# Hydro Aluminium Kurri Kurri Smelter Remediation Modification 1

State Significant Development Modification Assessment  
(SSD-6666-Mod-1)

September 2021

**Figure 2 |** Proposed location of leachate management infrastructure

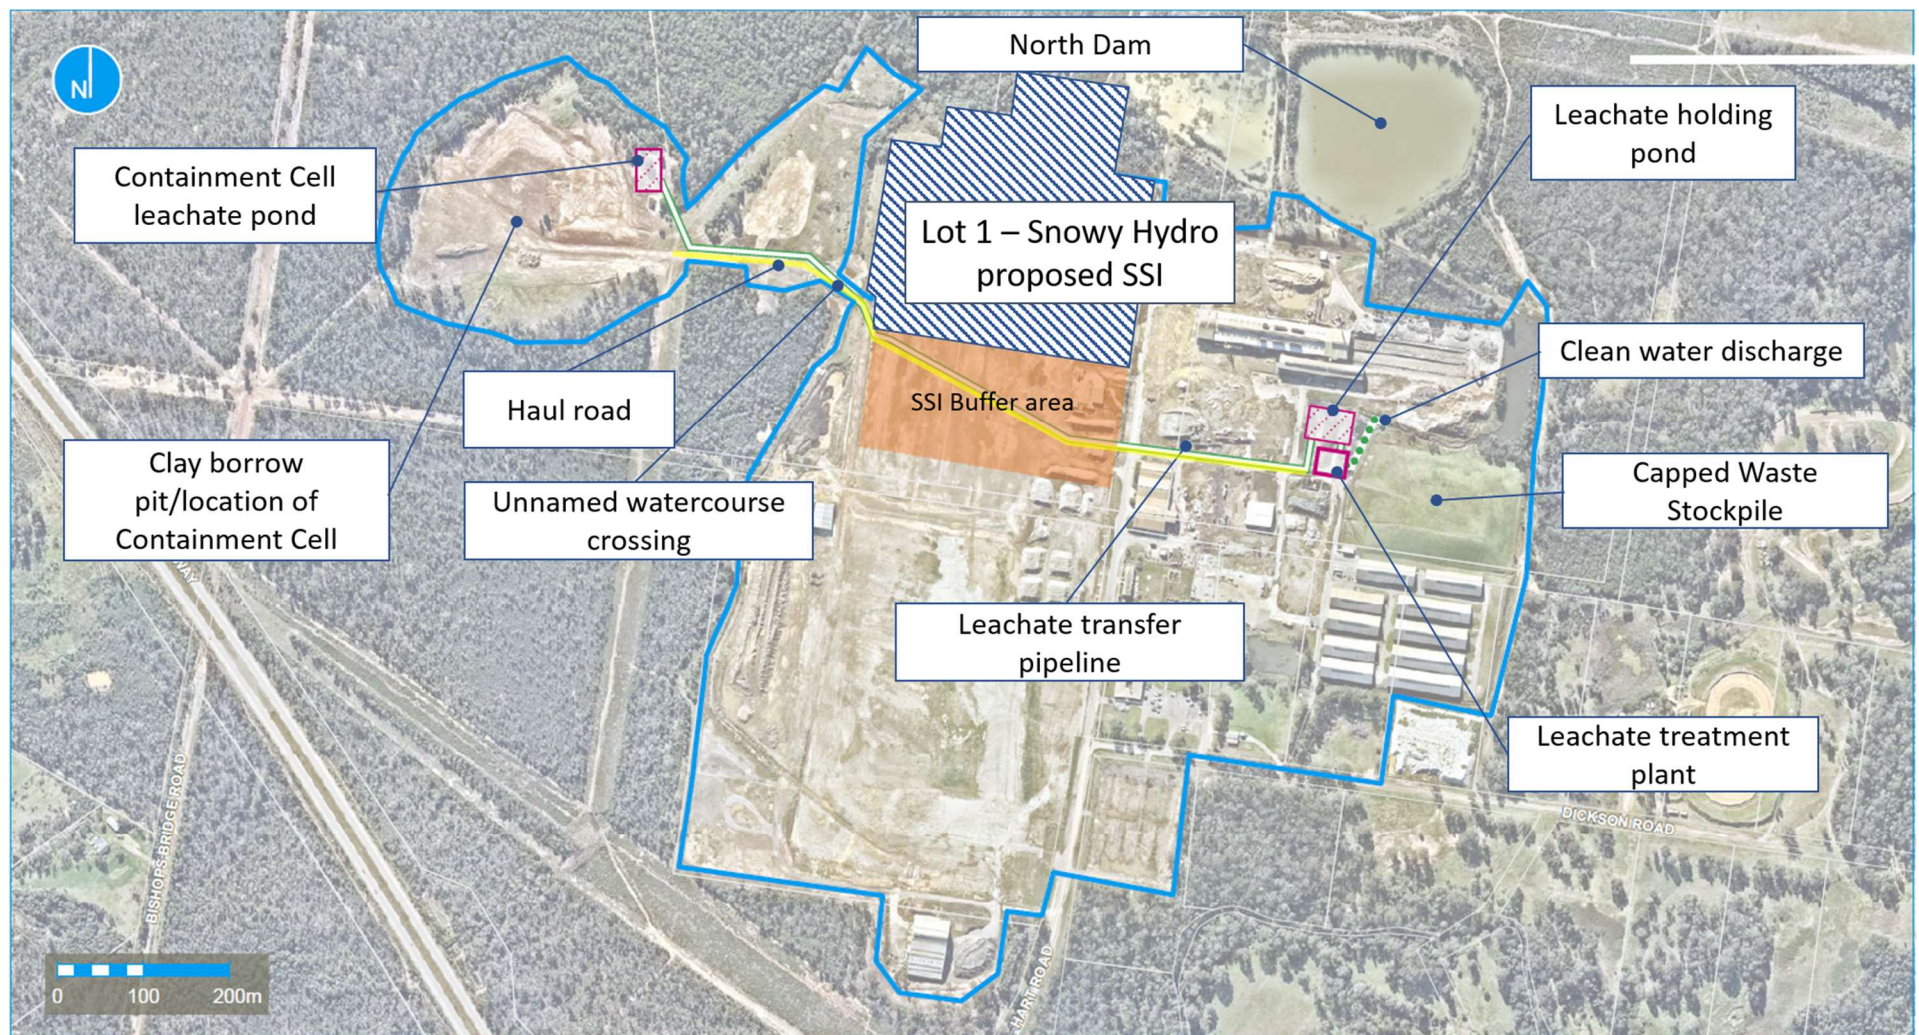
**DPIE – Water Group** and the **Natural Resources Access Regulator (NRAR)** required details for the location and method of the pipeline crossing of the unnamed watercourse near the containment cell.

DPIE – Biodiversity Conservation Division (BCD) had concerns regarding the proposed transfer pipeline crossing the location of a proposed SSI project. BCD also requested further details on operation and management during periods of significant rainfall.

The 950 m long leachate transfer pipeline would be installed at a minimum of 600mm below the haul road surface and backfilled to provide protection. Where the pipeline traverses the unnamed watercourse, it would be double-skinned and cross on the edge of the road. Where the pipeline crosses an access road, it would be trenched and backfilled into the road pavement.

The Applicant advised that all components of the TWTP would be constructed within a bund sized to contain any spillage or leaks. The leachate transfer pipe would be pressure tested prior to commissioning and monitoring of the quantity of leachate discharged into the transfer pipeline and weekly inspections for damage would allow early identification of leaks. To protect the pipeline, it would be trenched and backfilled into the road pavement and be double-skinned where it traverses the watercourse.
